# UNITED STATES PATENT AND TRADEMARK OFFICE

APPLICATION NO.	FILING DATE	FIRST NAMED INVENTOR	ATTORNEY DOCKET NO.	CONFIRMATION NO.
10/829,656	04/22/2004	Nick Boulachanis		6836

<b>Office Action Summary</b>	Application No. 10/829,656	Applicant(s) BOULACHANIS, NICK	
	Examiner Michael J. Early	Art Unit 3744

**DETAILED ACTION**

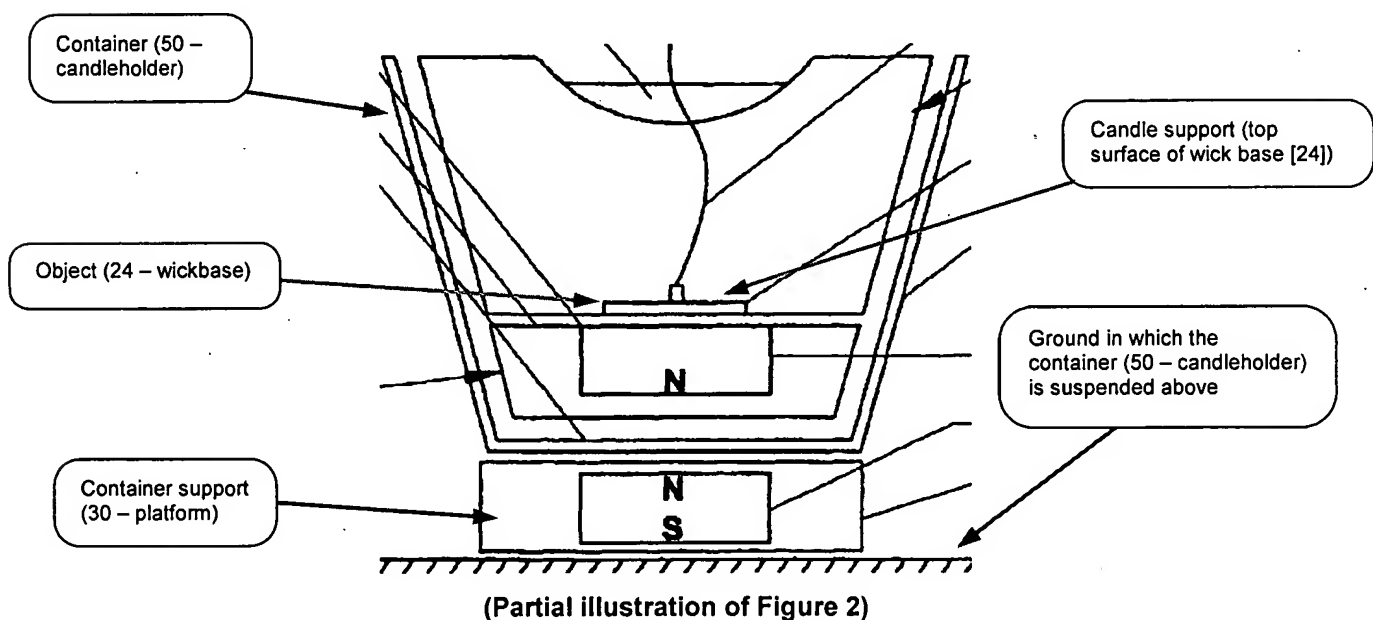
- a container (50 – candleholder) for receiving a liquid (26 – melted wax; col. 4, lines 53-66);
- an object (24 – wickbase), said object being substantially buoyant (by further of the fact that the candle floats on the wax, the candle must be buoyant) and supportable by the liquid while being at least in part submerged into the liquid (as seen in Figures 3, 4, 6);
- a first magnet (340 – second magnet) mounted to said object (as seen in Figure 9), said first magnet defining first magnet first and second magnetic poles having opposed polarities (as seen in Figure 9);
- a lit candle (20 – candle; Figure 2) selected from the group consisting of wax candles (see col. 4, lines 63-66), placed on the surface of said object (as seen in

Figure 2), and said object includes a support (as seen in the partial illustration of Figure 2 below);

- a second magnet (35 – first magnet) movable over a predetermined path relatively to said container (see col. 3, line 66 – col. 4, line 7), said second magnet defining second magnet first and second magnetic poles having opposed polarities (as seen in Figure 9);
- a container support (30 – platform) for suspending said container (as seen in Figure 2, the platform [30] suspends [or holds] the candleholder above the ground).

Fig. 8

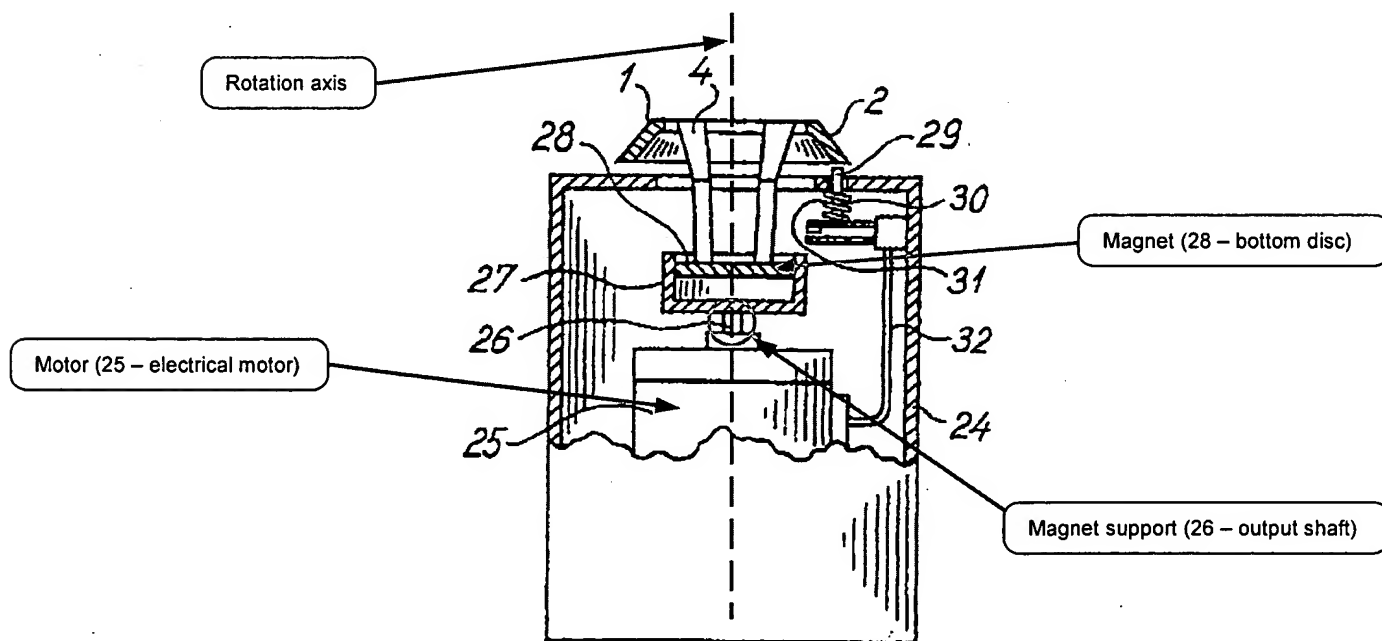
- a magnet (28 – bottom disc; col. 6, lines 4-8; Figure 8);
- a motor (25 – electrical motor; Figure 8) and a magnet support (26 – output shaft; Figure 8), said magnet being mounted to said magnet support (as seen in Figure 8) so that at least one of the magnet first and second magnetic poles is located eccentrically relative to said rotation axis (as seen in the illustration of Figure 8 below)
- a motor casing (24 – housing), said motor, magnet support and magnet being mounted into said motor casing (as seen in Figure 8).

It would have been obvious to one of ordinary skill in the art at the time of the invention to modify the existing apparatus of Gaudioso in view of Cafolla by incorporating a motor, magnet and magnet support that rotate in a circular pattern, as taught by Jensen, so
